# Beam Interlock System SPS CIBU Connection Review

Christophe Martin  
TE/MPE

### CIBU redundant signals

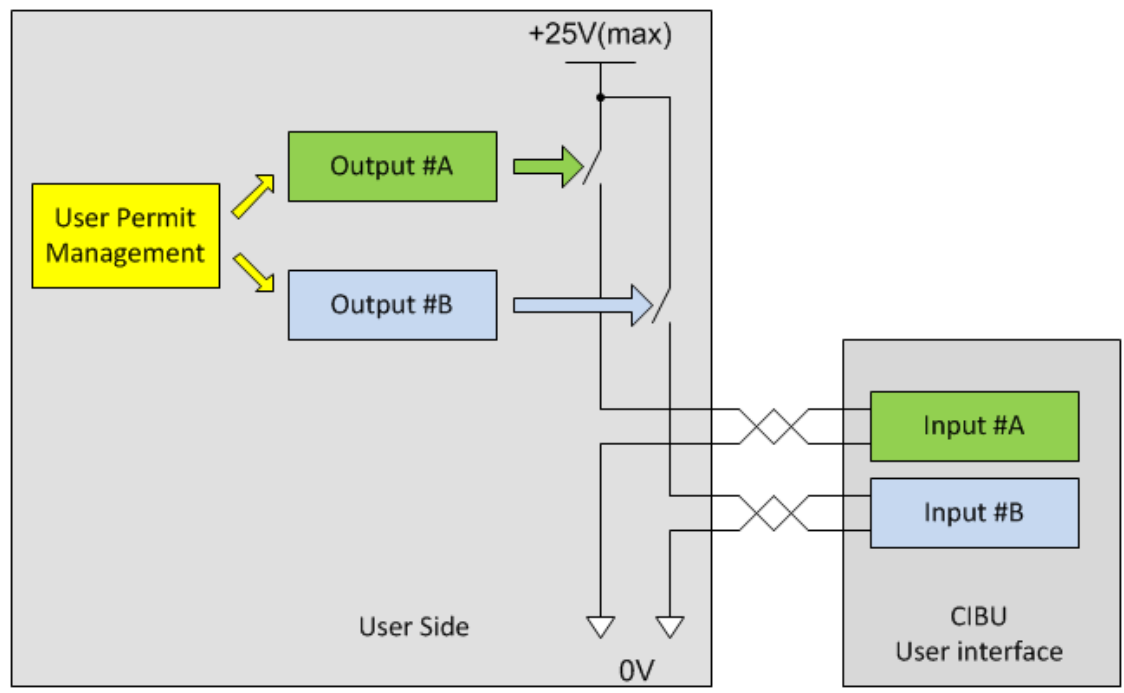
Distinct connection ✓ OK

- The redundancy is applied at least at the “Output stage” of the User electronic

### CIBU redundant signals

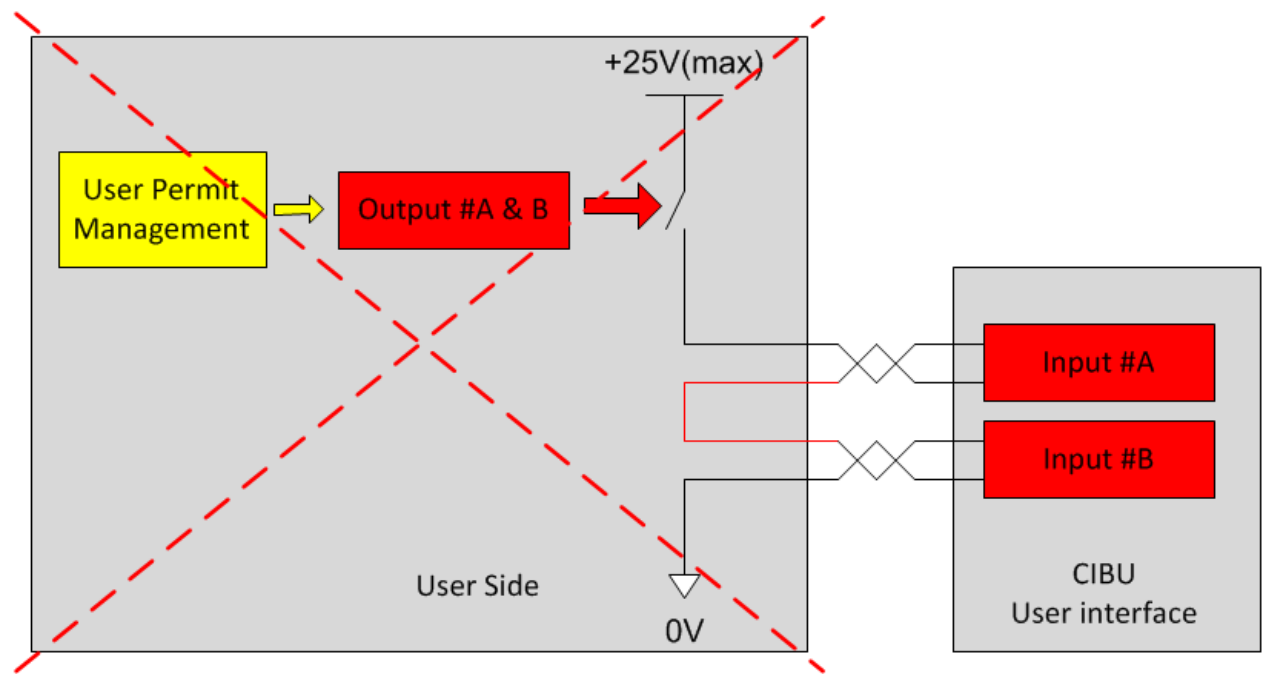
Serial connection      **NON-CONFORM !**

### CIBU redundant signals

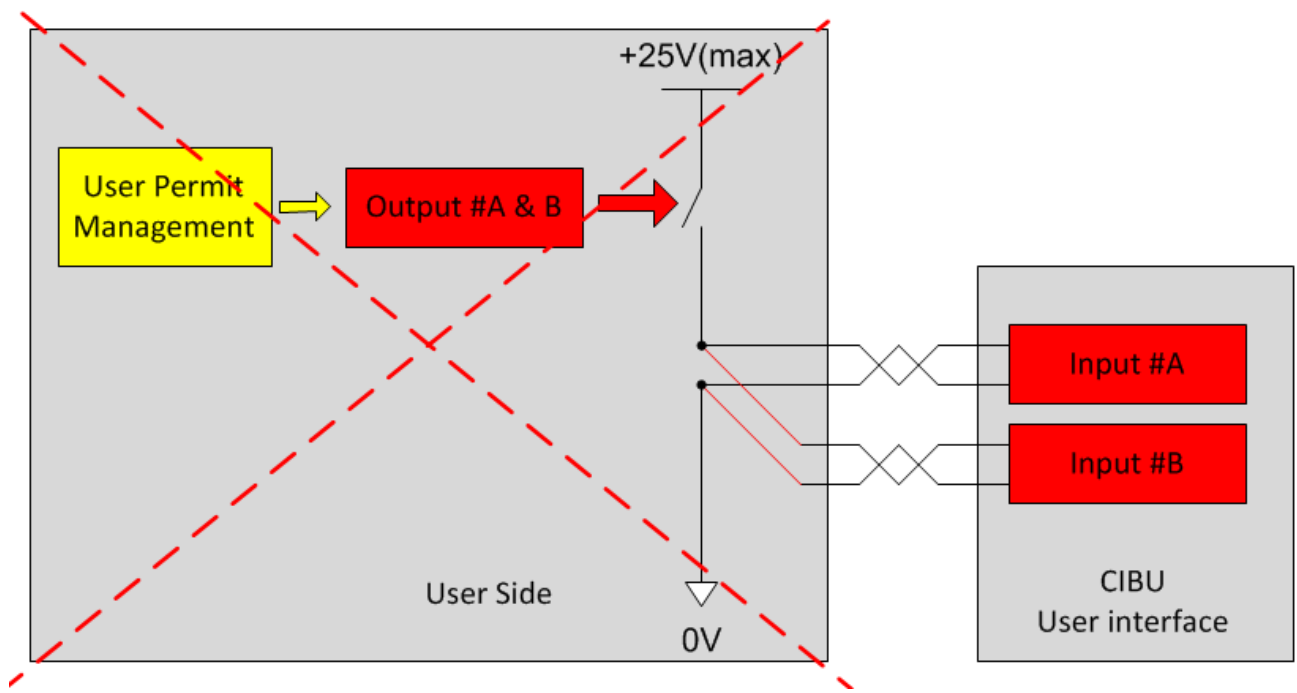
Parallel connection    **NON-CONFORM !**

### CIBU Switches position

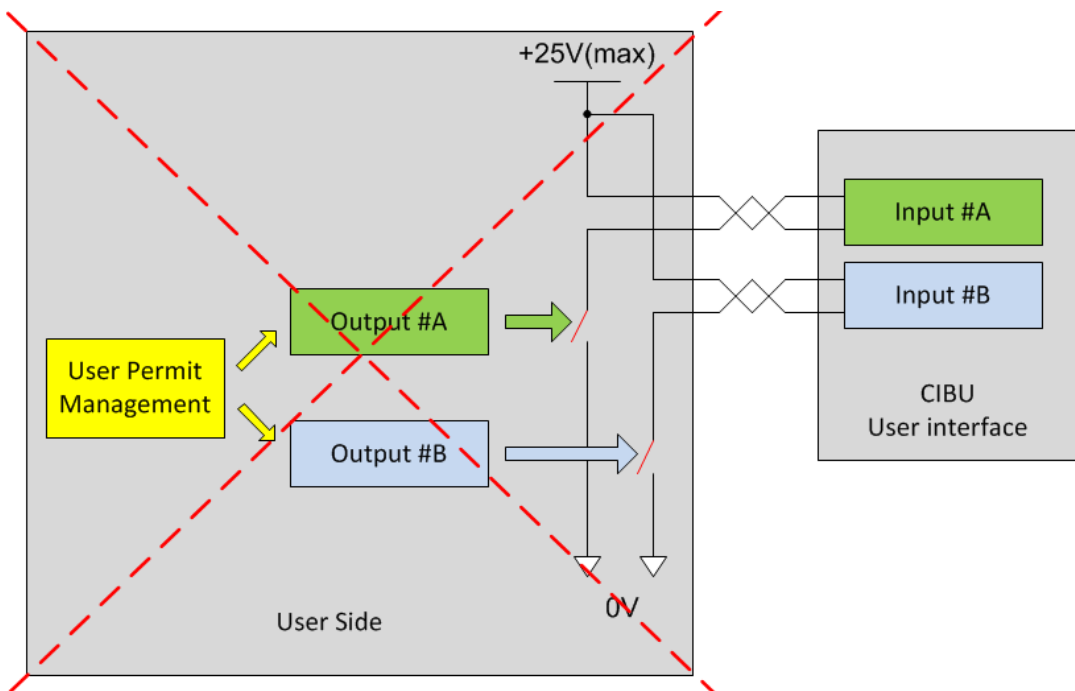
Wrong switches position    **NON-CONFORM !**

- This schematic was the recommended implementation in the CIBU user manual 1V4 up to 2009 !!!
- Following the presentation “CIBU Connection Review” of Benjamin Todd of December 2008, this schematic has been reported as “non-conform”

### User output impedance

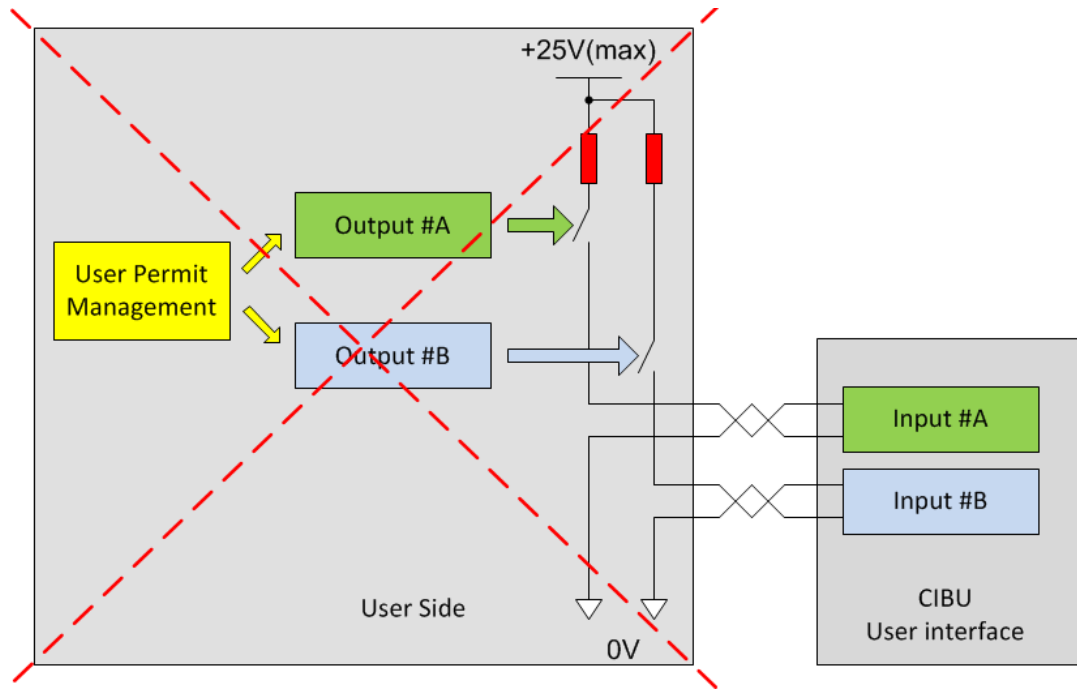
Serial resistor

**NON-CONFORM !**

- In the CIBU user manual 1V4 up to 2009 a misinterpretation can lead the users to provide a current into the CIBU.

The current loop is inside the CIBU, the user has to provide a voltage !

# CONNECTION DETAILS BETWEEN THE USER SYSTEMS AND THE CIBU

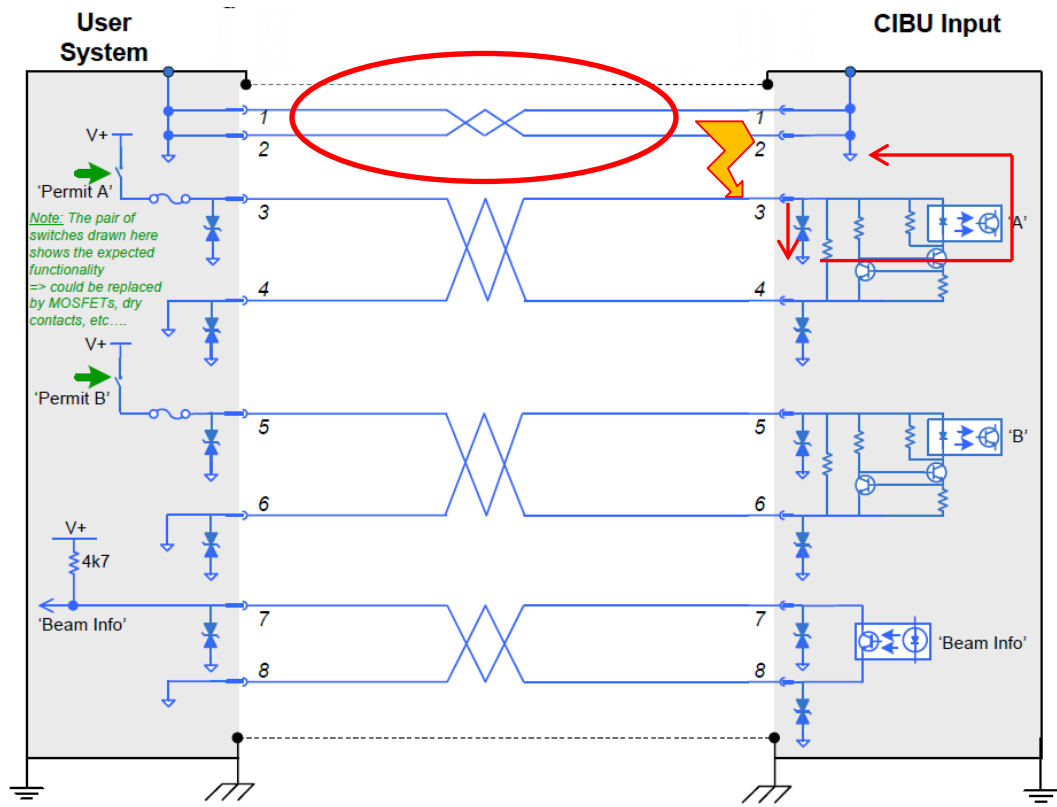
- If wire "1" and "2" are not connected, the cabling is not conform (No return path for the CIBU voltage suppressor in case of over voltage)

Figure 11: Principle of Interconnection for Complete EMC Compliance

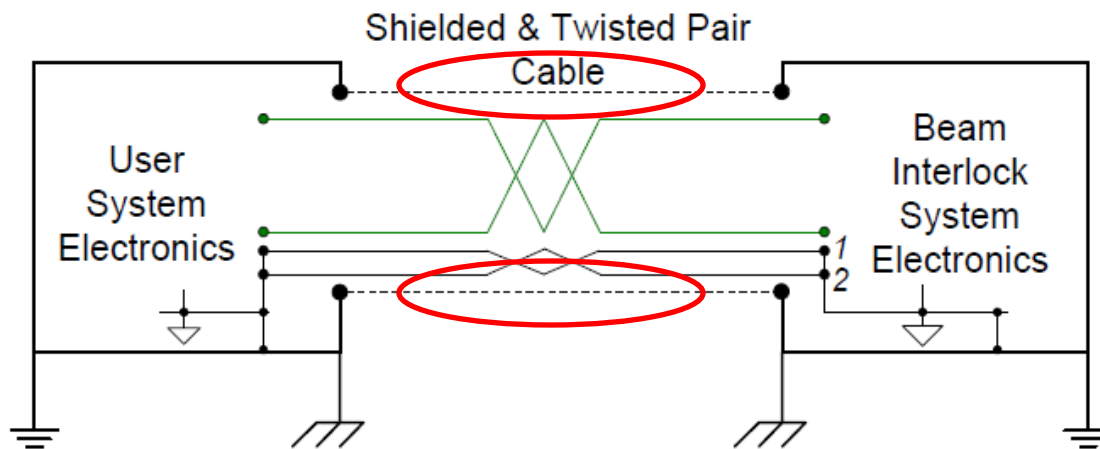
- The shielding must be present on the connection cable (visual control)

*Reminder: The interconnection cable between the User electronics and the CIBU is under the responsibility of the user!*

### SPS CIBU CONNECTION STATUS

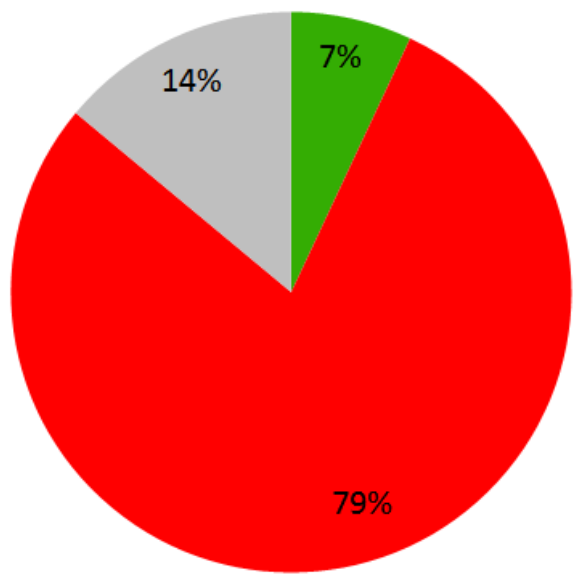
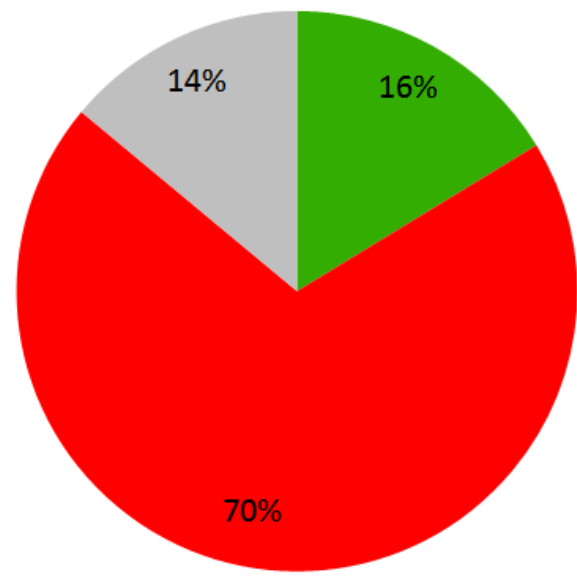
As found in June

After User improvement

## AS TESTED (Vacuum mid-July)

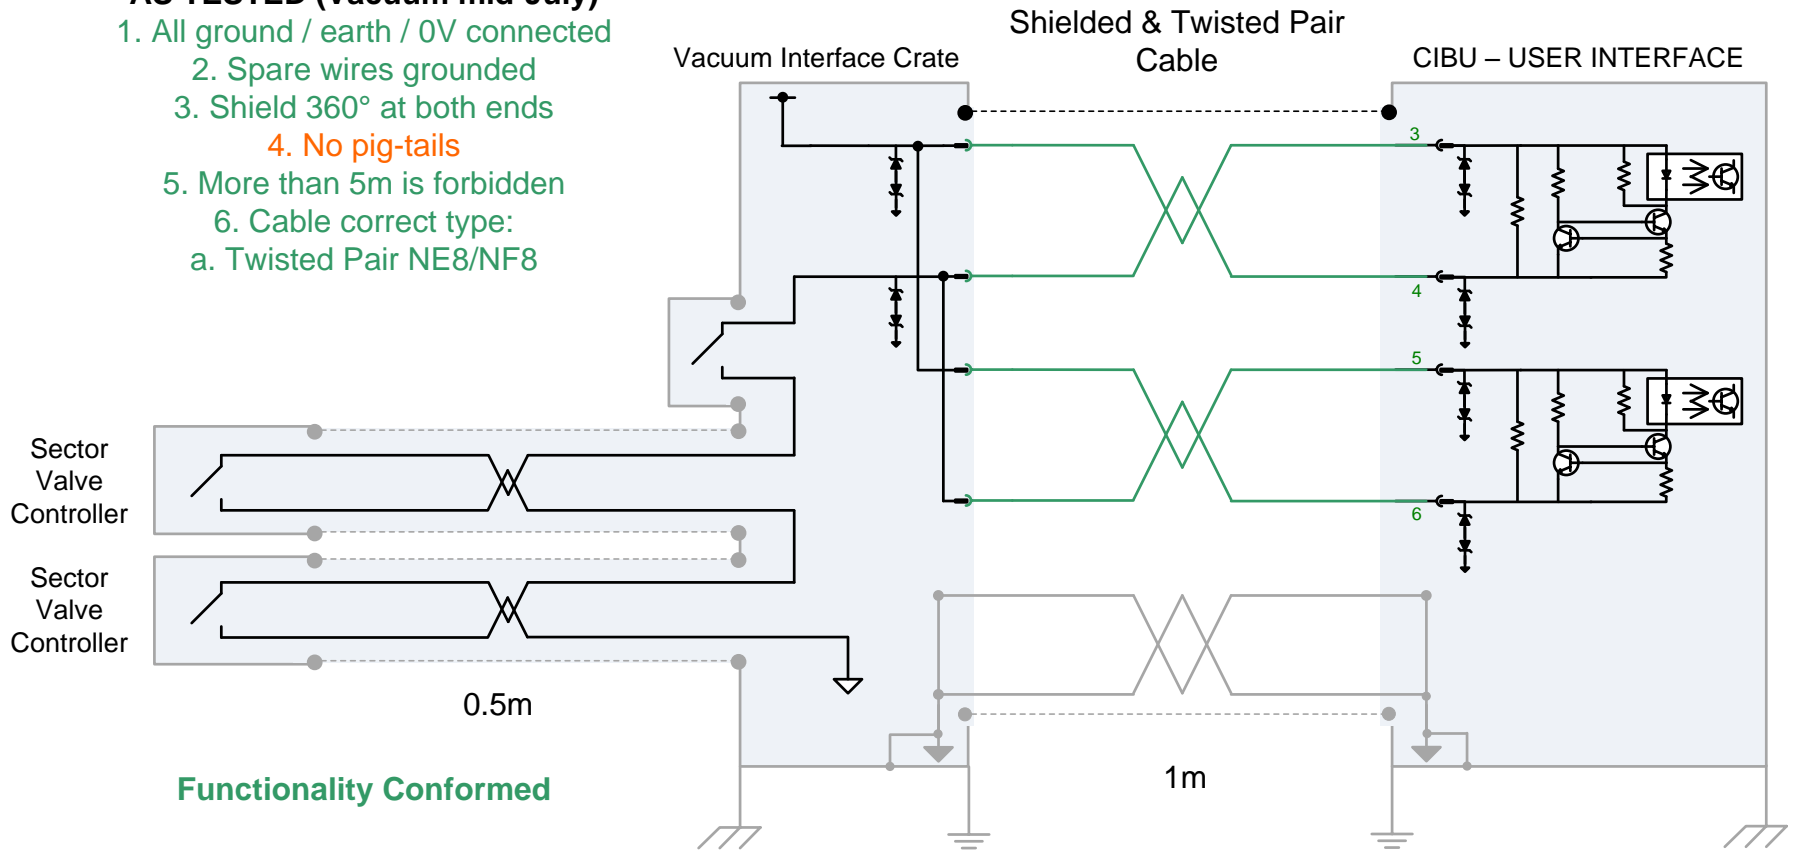
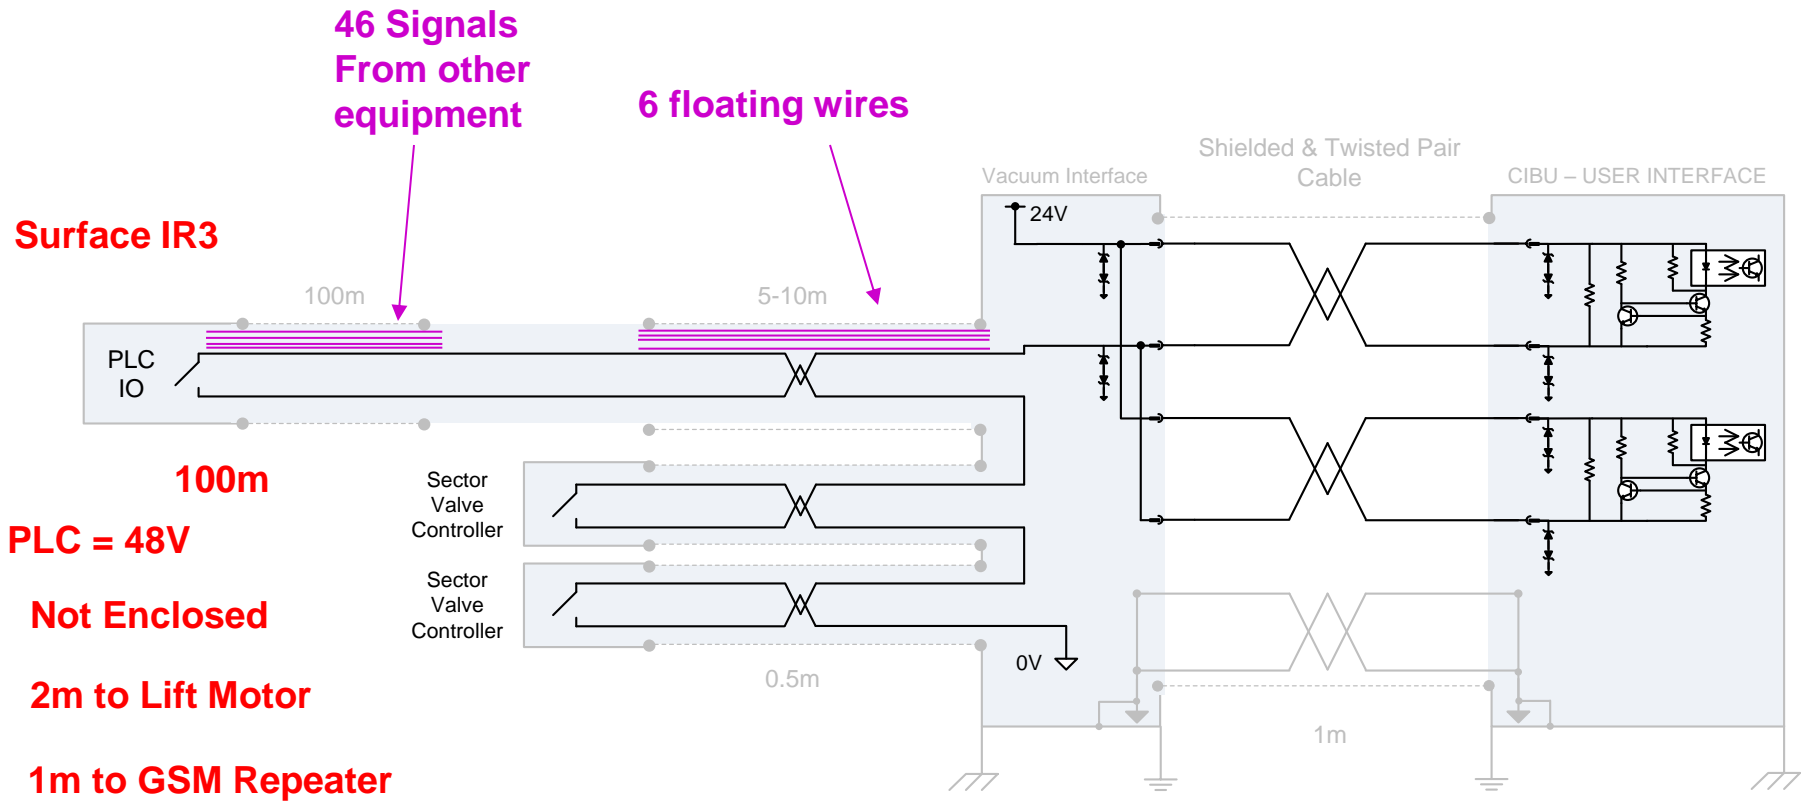
1. All ground / earth / 0V connected
2. Spare wires grounded
3. Shield 360° at both ends
4. No pig-tails
5. More than 5m is forbidden
6. Cable correct type:
  - a. Twisted Pair NE8/NF8

**WHEN CONNECTED  
CIBU ALWAYS TRUE  
(next slides)**
